## Department of Planning & Community & Economic Development

February 24, 2010

We have looked at the revised concept ULI prepared for South Pinckney Street by Valerio Dewalt Tran (VDT) and have discussed with other City staff regarding your proposal. Ald. Verveer and the Mayor's Office have also been included in the discussions.

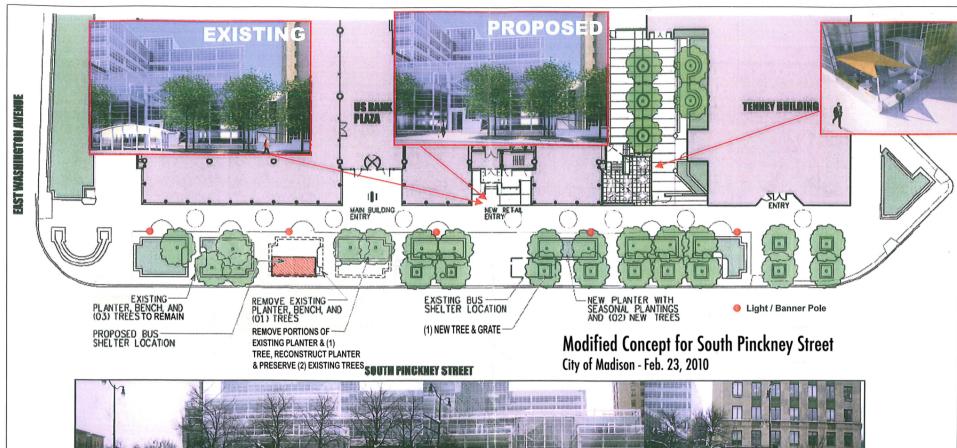
- 1. The existing bus passenger shelter location will be moved from its present location near the new entry to the L'Etoile Restaurant and Gastropub to the north.

- 2. The new location of the bus passenger shelter will be at the third planter south of East Washington Avenue. From an operational perspective, this works much better for Madison Metro than the second planter south of East Washington.

- 3. At the entry to the US Bank lobby we are proposing the removal of approximately one-half of the existing planter and one tree. We propose keeping two of the trees. The two trees we propose keeping are healthy, provide an attractive tree canopy, and have been there from the original Capitol Square improvements in 1979. We find no compelling reason to totally remove them as part of the project.

- 4. As per the plan from VDT, we agree that a new planter reusing existing stone curb and new trees would work well to balance the area flanking the new entry to the L'Etoile Restaurant and Gastropub. A new planter with two trees and associated landscaping, as well as a new tree in a tree grate works well for this area.
